NUMBER: SB 500-32-015, Rev D
MODEL: ECLIPSE EA500
SUBJECT: Right Hand MLG Trunnion Repair/Replacement

Mandatory

This bulletin repairs or replaces the main landing gear trunnion.

This Service Bulletin provides procedures to repair or replace the Main Landing Gear Trunnion on an Eclipse aircraft.

Figure 1. MLG Main Fitting Nameplate Location

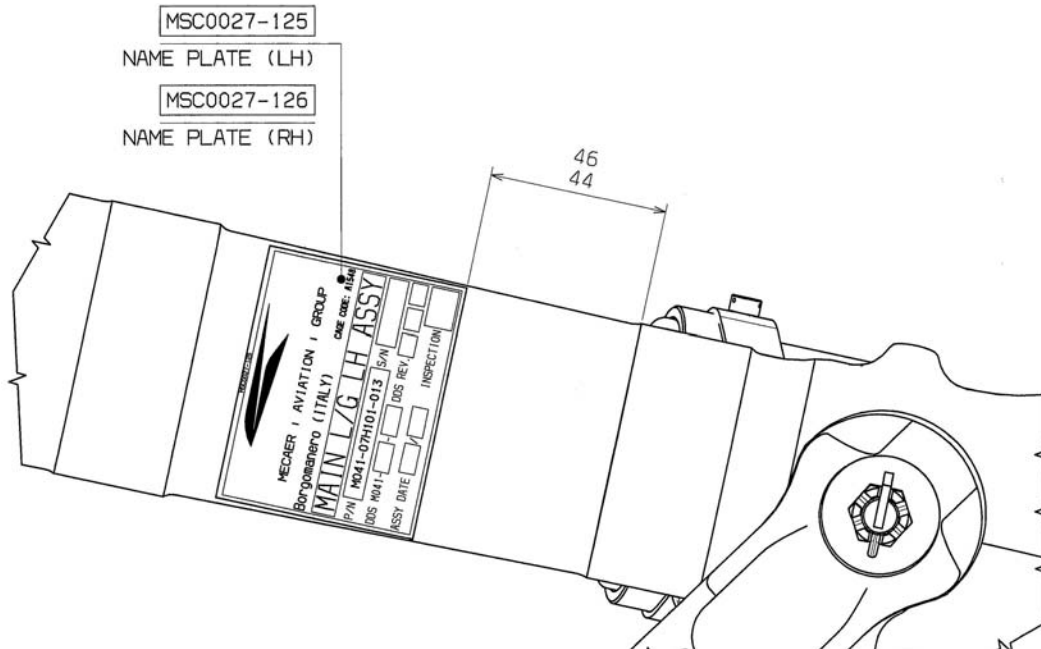
- (3) MFG DATE/ASSY DATE to remain as on the original nameplate (do not change the date to the current date).
- (4) Original nameplate shall have a large black “X” marked across the nameplate from corner to corner with permanent marker to void the nameplate. Original nameplate to remain attached to the old Main Fitting.
- (5) Locate position for new nameplate installation on the new MLG Main Fitting 44-46 mm (1.73-1.81 inch) up from the lower strengthening band in accordance with [Figure 1](#).
- (6) Pre-bend new Nameplate to conform to the contour of Main Fitting.

- (7) Prepare the Main Fitting surface in the location of the nameplate by thoroughly cleaning the surface with Aliphatic Naptha TT-N-95B Type II (or equivalent).
- (8) Ensure the Main Fitting surface is completely dry after cleaning by using a clean dry cloth.
- (9) Remove adhesive backing from the nameplate.
- (10) Apply Epoxy Adhesive MMM-A-132, Type 1, Class 3 (Metalset A4 or equivalent) under the entire surface of the nameplate.
- (11) Attach the nameplate to the MLG Main Fitting in the correct location.

- (12) Apply liberal bead of adhesive around all edges of nameplate.
- (13) Temporarily secure nameplate to Main Fitting using non-marking tape (Masking Tape or equivalent).
- (14) Allow adhesive to dry.
- (15) Remove temporary tape.
- (16) Install Trunnion per Section F. — MLG Main Fitting Installation.

Figure 2. Trunnion Identification Pad Area

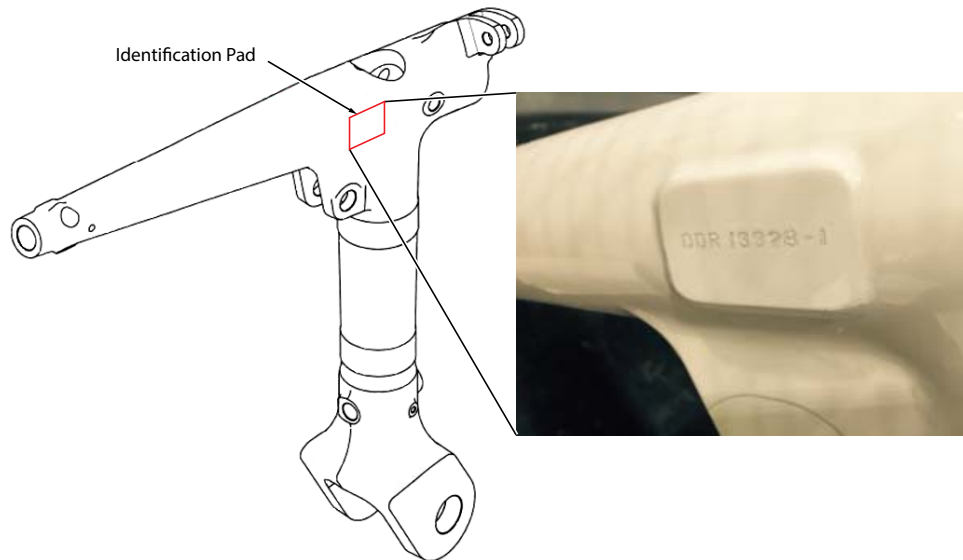
- (a) If trunnion was replaced per TSR from EAI, POST SB 500-32-012, and contains a Service Bulletin (SB) number and/or a DDR# as shown in [Figure 2](#), complete compliance record and return to EAI. No further work under this SB is required.
- (b) If trunnion was not replaced, based on facility authorization, repair or replace trunnion per step 3.B. or 3.C. of this bulletin, as applicable. See “Facilities Authorized to perform Service Bulletin:” on [page 3](#).

- (1) Ensure the replacement trunnion contains at least one of the following (Refer to Figure 2):
 - Marked indication of SB completion on or near the identification pad area.
(Accomplished after repair procedure.)
 - Engraved DDR# from Mecaer on the identification pad.
